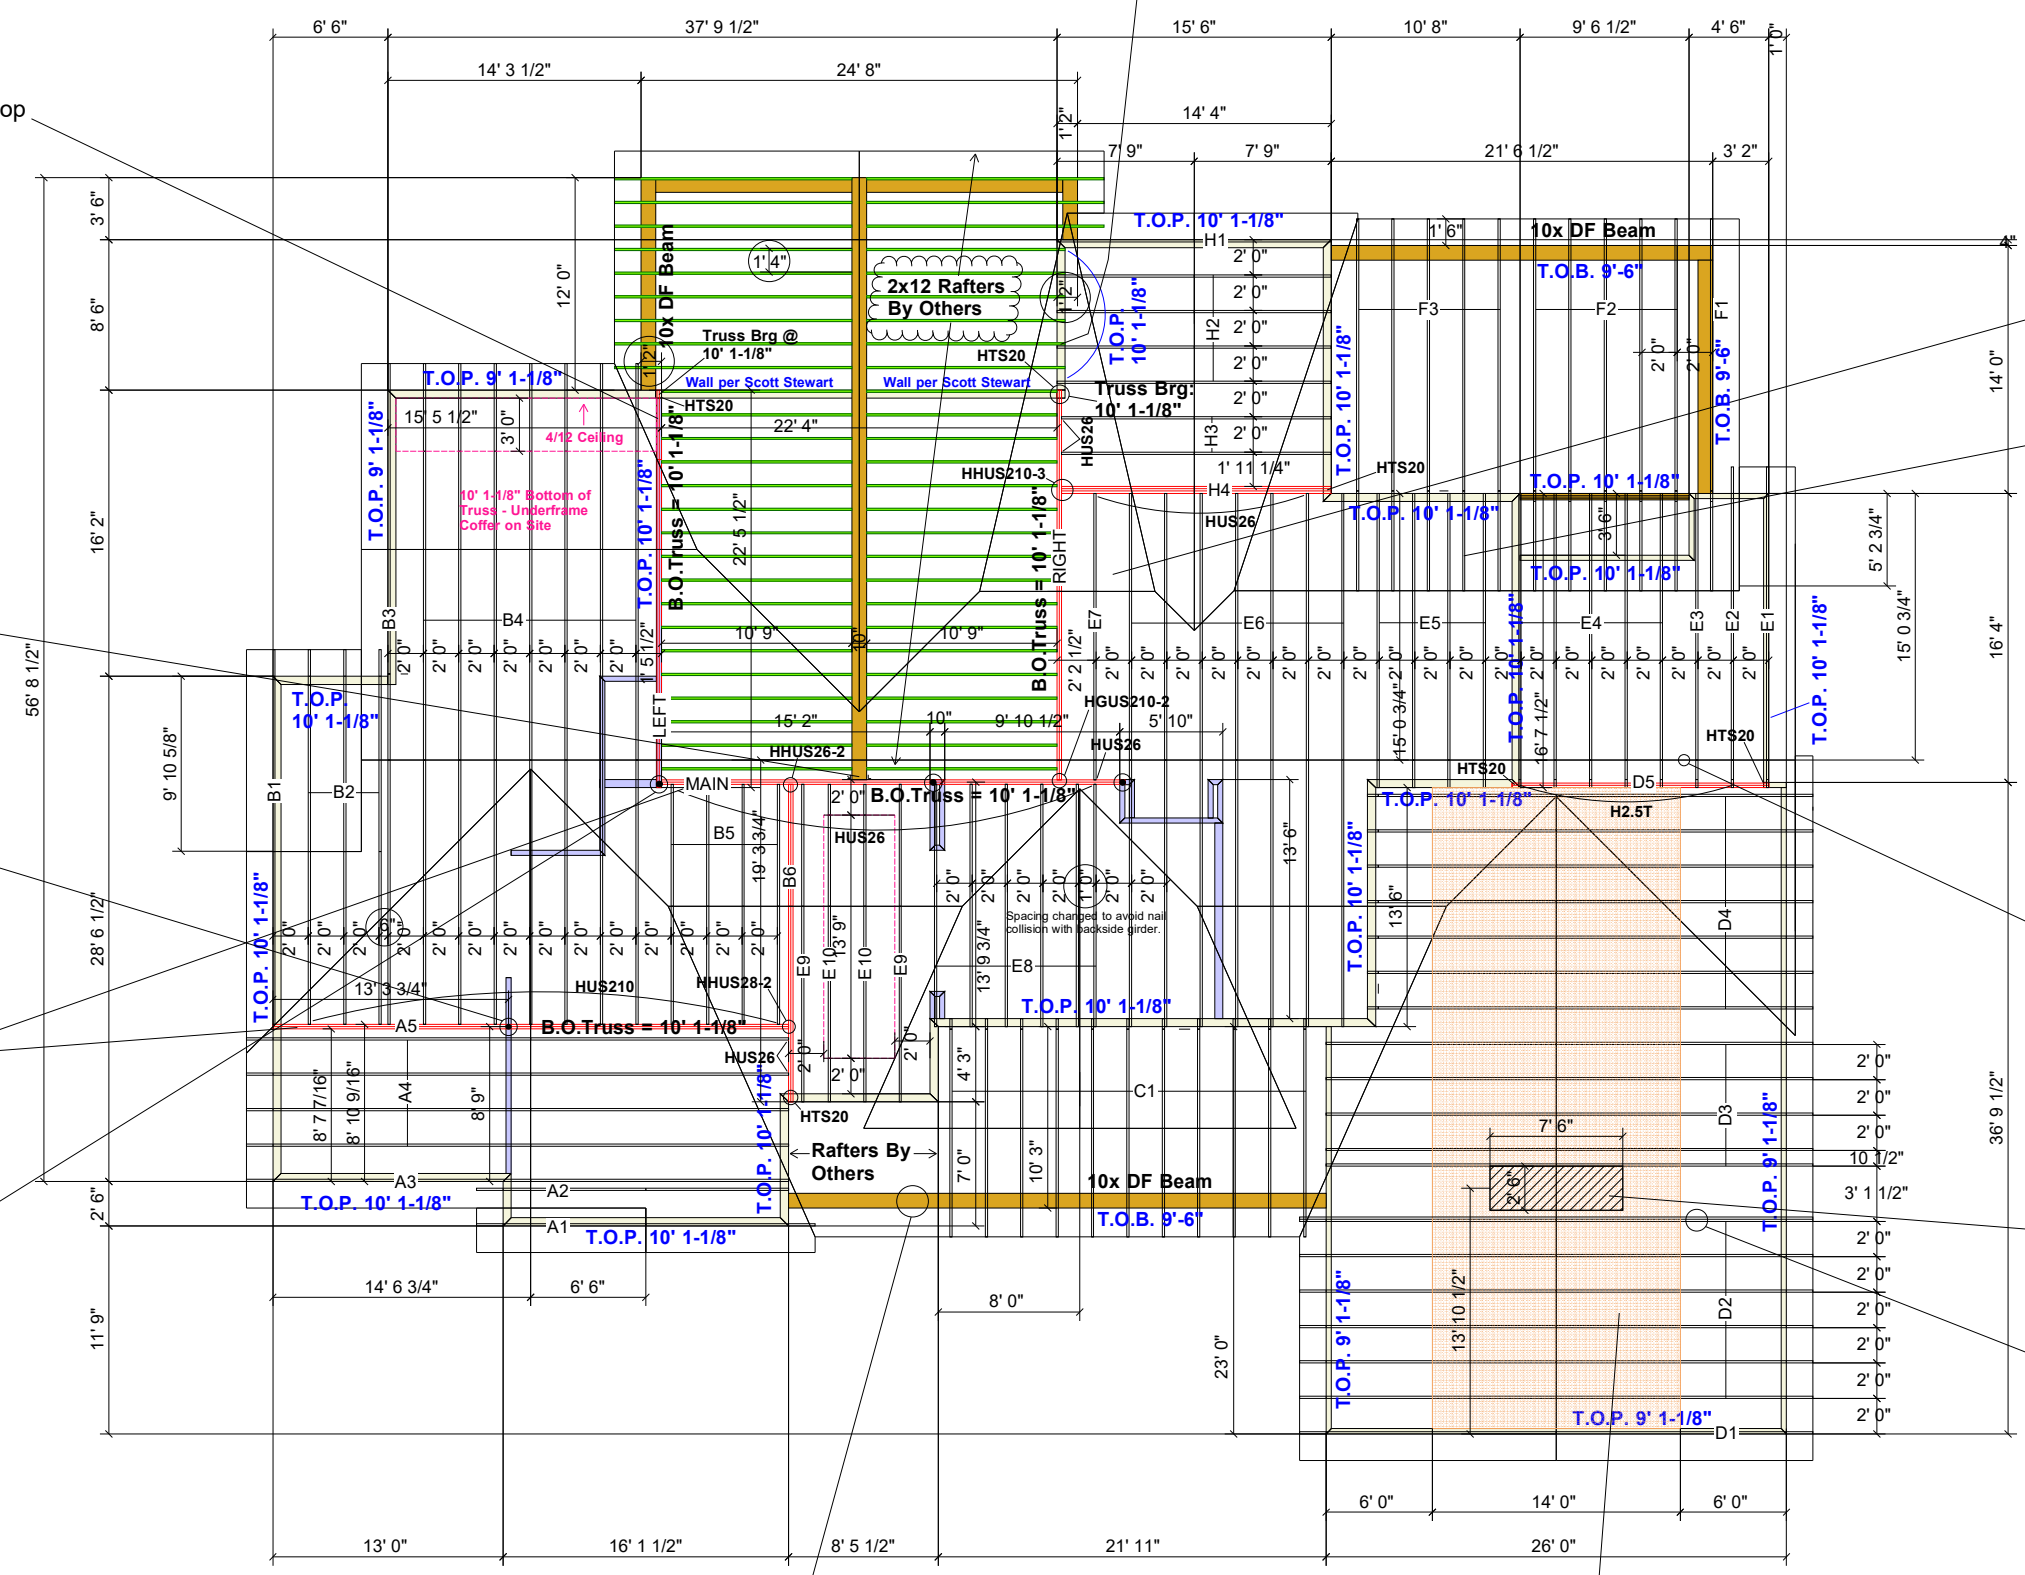
Apprx 1/2" of the top edge corner of the "LEFT" truss may protrude thru the sheeting. It is OK to bevel top chord, to the roof sheeting.

Girder truss brg size requirement (and uplift connections) over Pipe Columns MUST be reviewed by Engineer of Record, TYP.

A5 and MAIN girder trusses are NOT symmetrical - Do not install in reverse.

MAIN truss bears onto LEFT truss. No hanger needed. Connect together with (1) HTS20 for uplift.

Apprx 2/12 Pitch @ Cricket
NOTE: The girder truss labeled "RIGHT" does NOT have the cricket built into it. Purposely held low, so that cricket pitch can be perfected on site.

Post down under truss tails here @ 48" OC - Tails are creating overframe.

Bessler Model 100 Attic Stair. Adjust truss spacing as req'd. See separate stamped D2 Truss (showing 2-PLY), stamped by Robert Brock, P.E.
Only this circled D2 truss needs to become a 2-PLY. The D3 adjacent to the Bessler 100 is rated for 24" OC which covers that side.

Trusses will have 10-1/8" heel height. Match rafters to trusses.
